Memorandum

SUBJECT: Office of Planning Report for Large Tract Review Case No. 2015-03
901 4th Street, N.W. (Square 527, Lot 20)

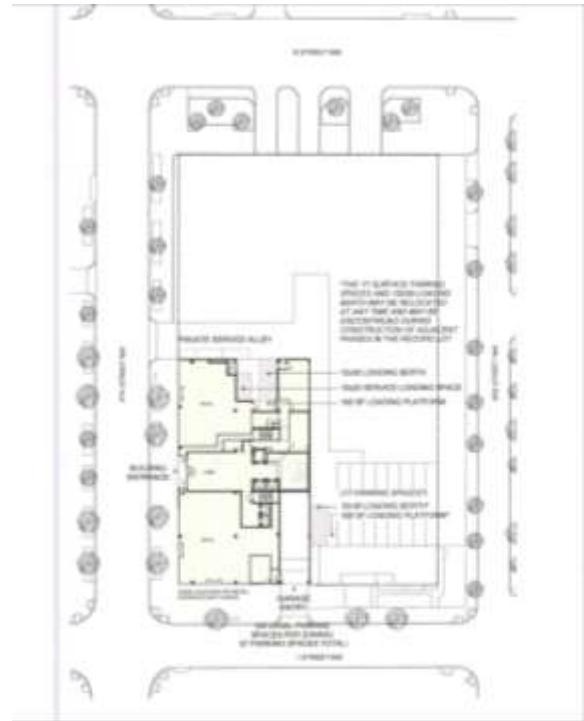
The applicant proposes to establish a curb cut from Eye Street for access to the below-grade parking garage beneath the building, instead of from the private alley on the north side of the building for security reasons. Additional information is necessary to document why adequate security cannot be provided from the alley, and why access from Eye Street would be more secure to the satisfaction of DDOT and the Public Space Committee.

DDOT indicated that the proposed curb cut from Eye Street is contrary to its policy and standards on site access, which does not permit curb cuts if alley access is available (see DDOT Design and Engineering Manual 31.2.2.1). Garage access and necessary security measures should be provided from the newly established private east-west alley on the north side of the building in conformity with DDOT standards. Any request for a curb cut would require approval from the Public Space Committee.

The project proposed by this Large Tract Review Application is generally consistent with the purposes and goals of the LTR regulations and is not inconsistent with the Comprehensive Plan. OP recommends the applicant consider the recommendations made by District agencies as noted above, and to continue to work with DDOT and the Public Space Committee to resolve the issue of the proposed curb cut from Eye Street prior to the issuance of building permits.
